RESPONSE TO ENVIRONMENTAL HEALTH CONSULTATION

Hayling Padel - Mill Rythe Lane, Hayling Island

Planning application: APP/26/00391

Environmental Health reference: PR202607-113254, dated 3 August 2026

Drawing A116: Drainage Plan, Mill Rythe Lane Padel (IJ Murray Associates Ltd, 19 August 2026)

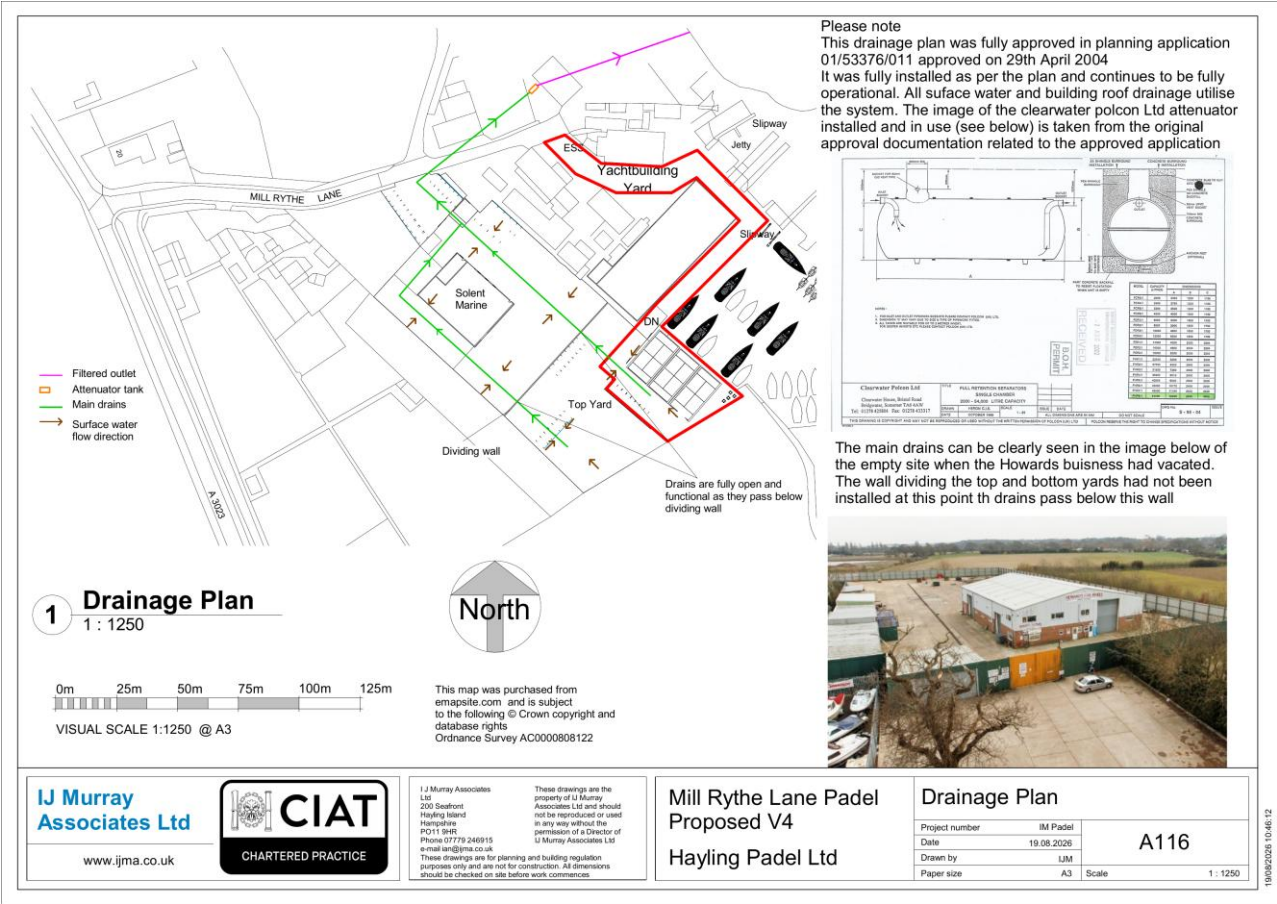
We also apologise that the original submission did not explain how roof water from the covered courts would be managed. We are pleased to address that omission by submitting Drawing A116, included at Appendix A below and as a separate full size attachment.

Roof water from the padel structure will be directed to the existing linear drainage channels serving the top yard. These discharge through the existing attenuation tank and oil interceptor to the confirmed filtered outlet, as shown on Drawing A116.

This drainage system was approved under planning permission 01/53376/011, dated 29 April 2004. The landowner has confirmed from direct knowledge that the drainage channels, attenuation tank and oil interceptor were installed, remain operational and continue to serve the top yard. The landowner also retains responsibility for maintaining this drainage system.

We hope Drawing A116 and the above confirmation provide the information needed to address the drainage point. If Environmental Health requires any specific further clarification, we would be pleased to provide it.
